**WALLACE J. TOSCANO A.I.A.  
ARCHITECT**

RE: Weinhoff Residence  
3 Maple Way  
Armonk NY 10504

## RPRC DETERMINATION LETTER

Project Description: Tear down and new construction.  
Street Location: 3 MAPLE WAY  
Zoning District: R-2A Tax ID: 101.04-2-74 Application No.: 2022-0870  
RPRC DECISION: RPRC - Requires Planning Board  
Date: 11/01/2022

**FLOOR AREA CALCULATIONS WORKSHEET**

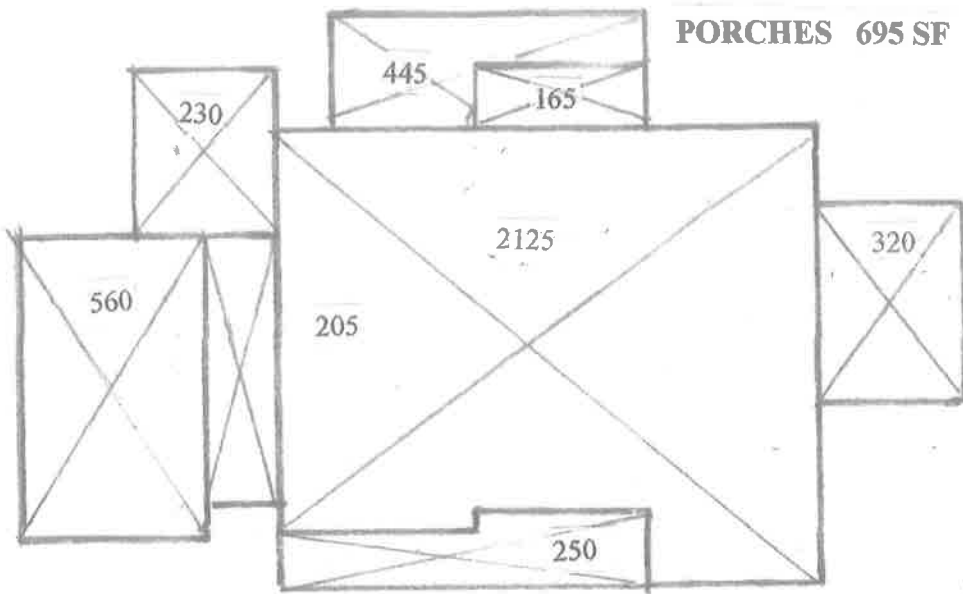
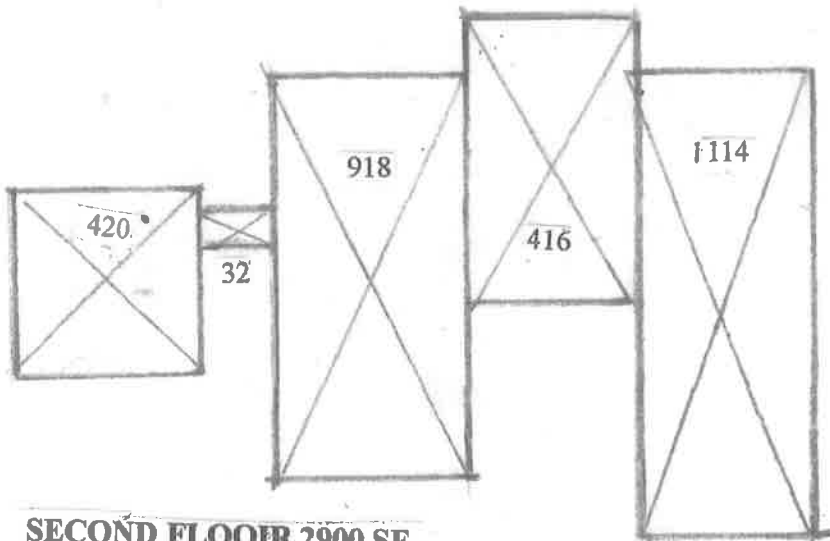
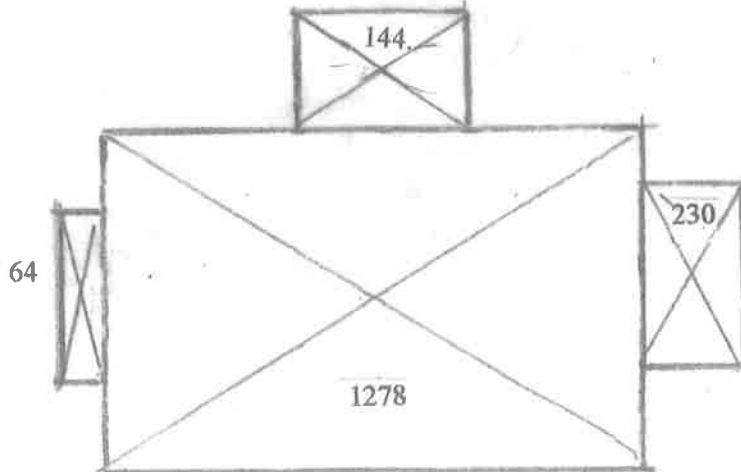
*yo* 5 The proposed gross floor area on the site exceeds the maximum permitted amount. Specifically, 10,125.2 square feet of gross floor area is permitted and 10,394 square feet is proposed. The size of the house (or pool house) shall be reduced to comply with the Town Code.

PROPOSED SITE PLAN

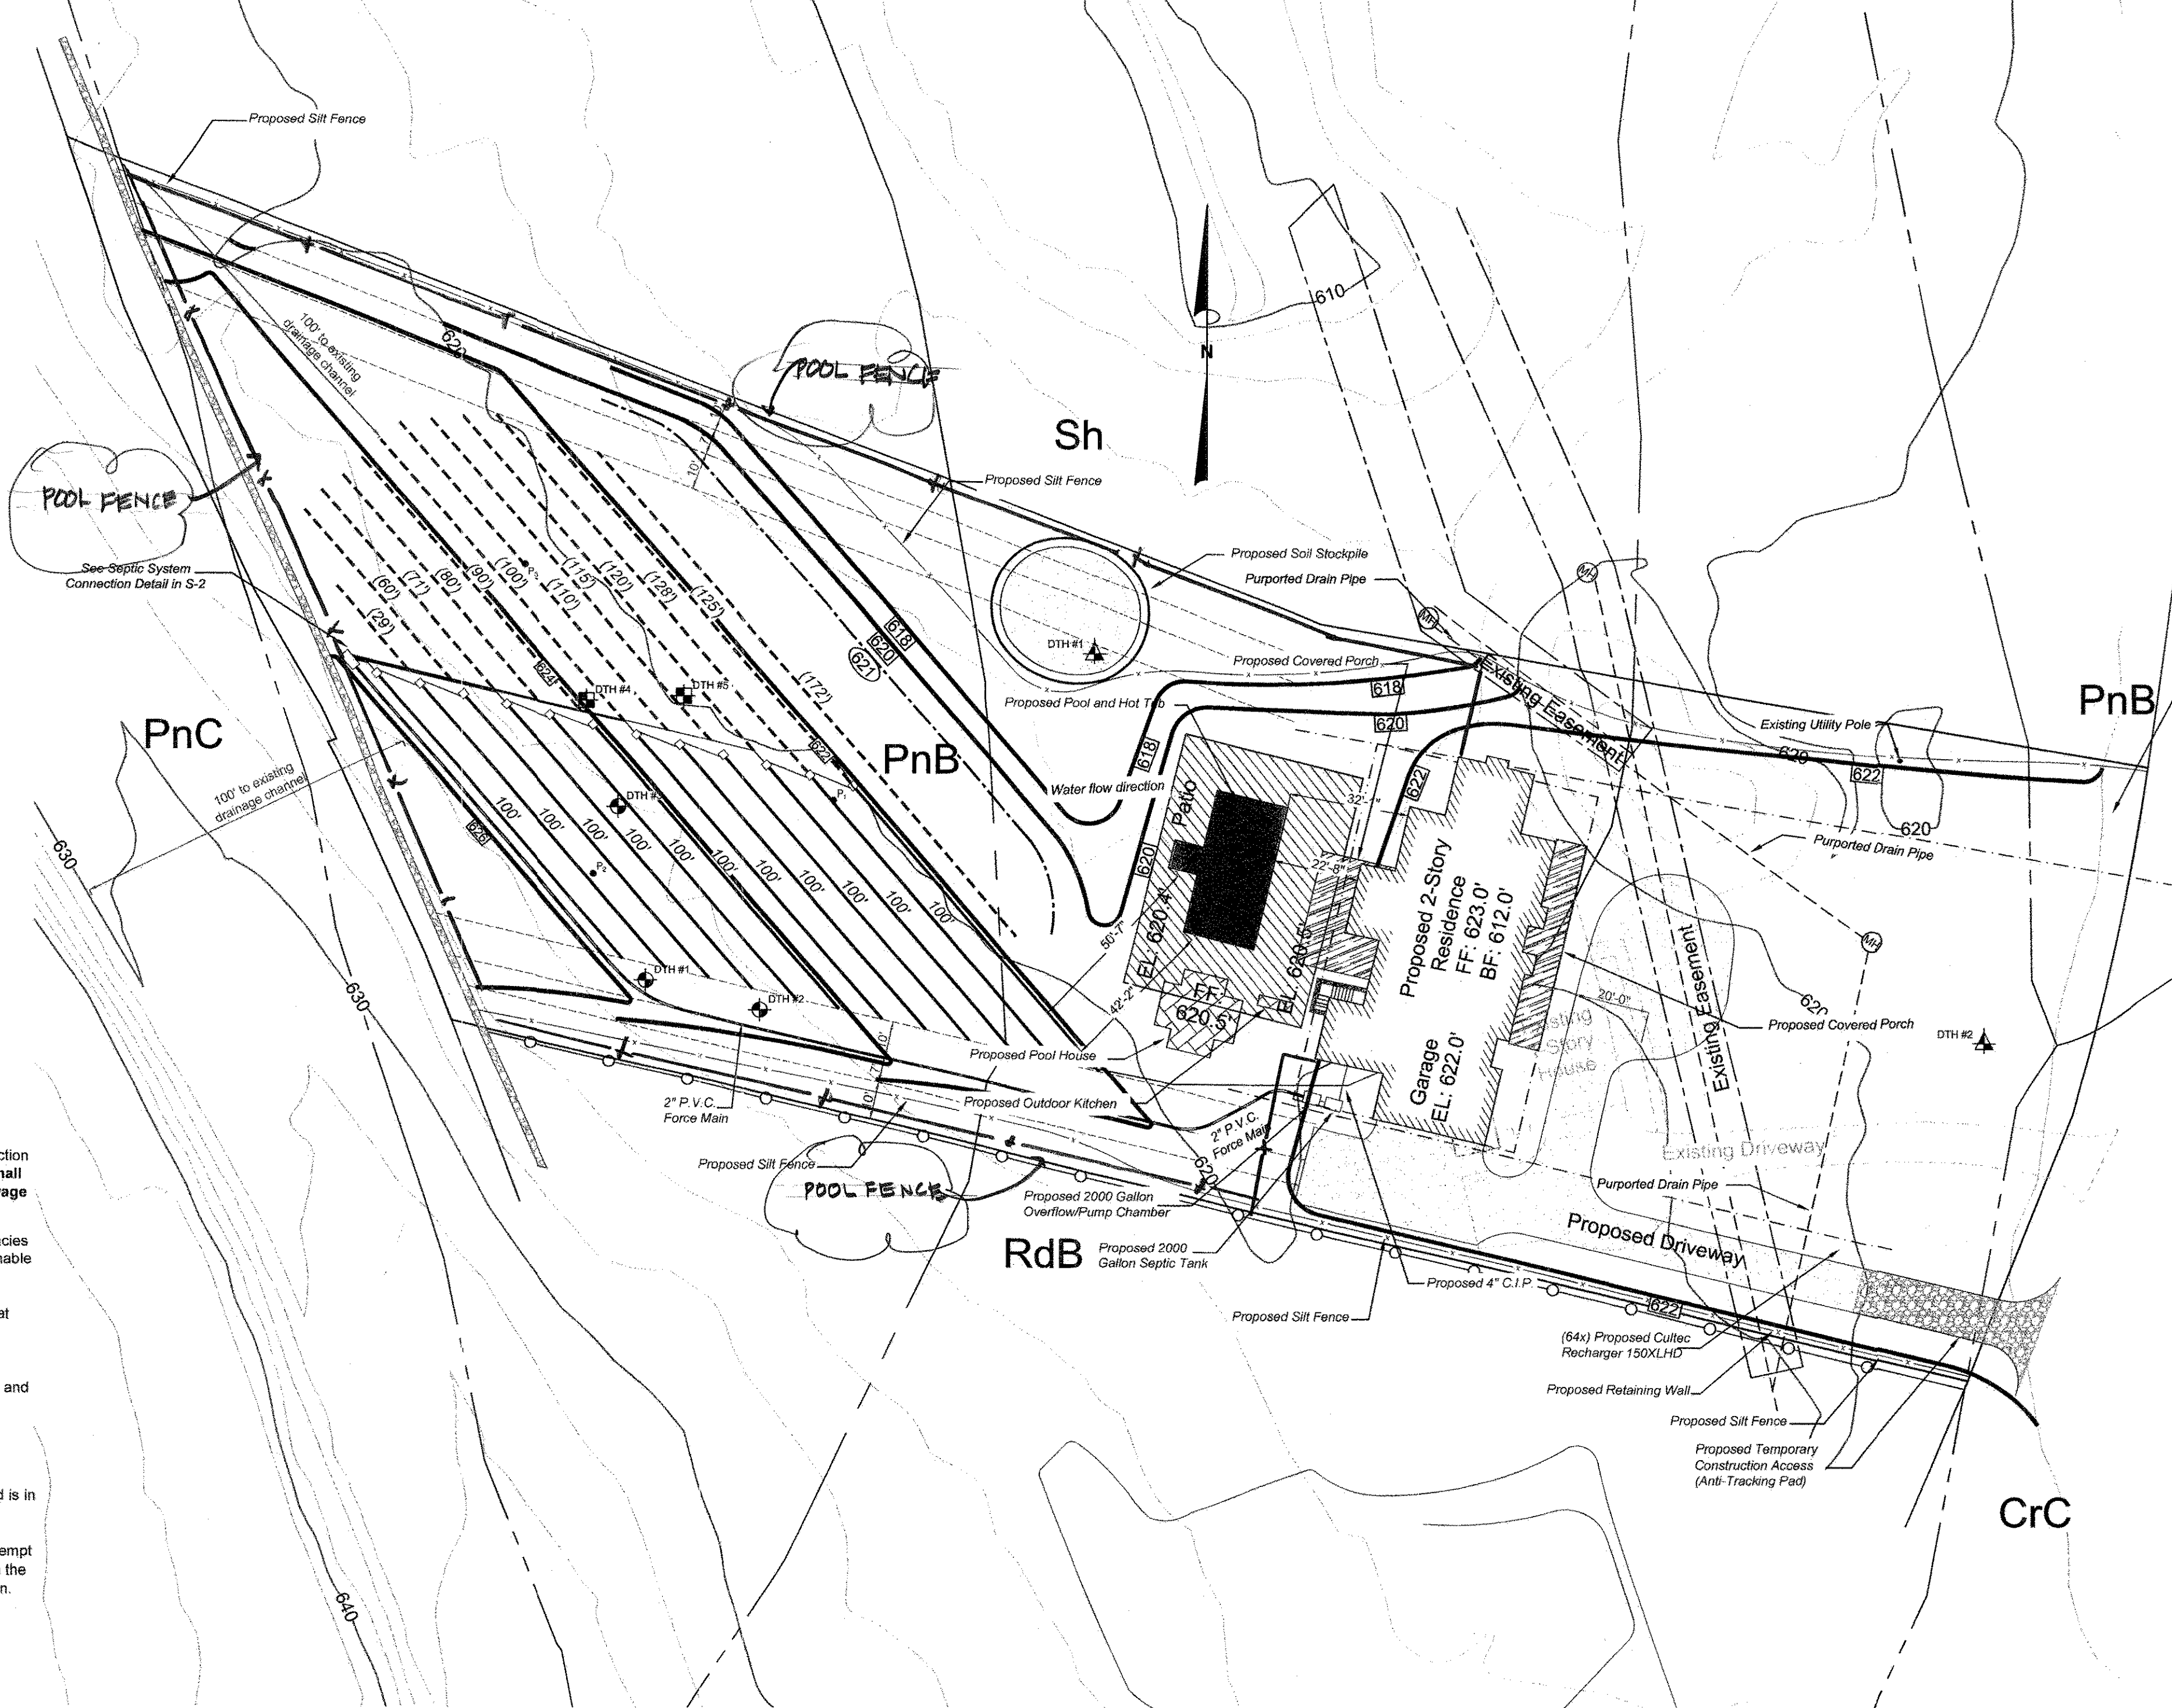
*yo* ~~1~~ The site plan depicts two curbcuts. The site plan shall be revised to eliminate a curb cut. In the alternative, the Planning Board can grant approval for two curb cuts.

7 The site plan should be revised to depict a pool fence and include a pool fence detail

23 The plan shall illustrate and note that all driveway curb cuts shall be a maximum of 18 feet wide.

1. We have revised the curb curb cuts complying with current codes. See drawing 25
2. Our landscape plan drawing number 26 has been corrected and shows the location of the trees post to be removed
3. We have moved the building to the north which then increases the dimension between the curb cut of the parking Area so as to allow for larger trees See drawing. 25
- 4 See letter from Dan Sherman our landscape Architect
- 5 The original calculation for floor area ratio were incorrect ,we are resubmitting new information
- 6 We have noted the the proposed building Heights on both main house and the pool house See drawings 5 and 24
- 7 We have added a detail of the pool fence around the perimeter of property on drawings 25 and 27

23 The plan has been revised so that the curb cut is a maximum of 18 feet wide. See drawing 25
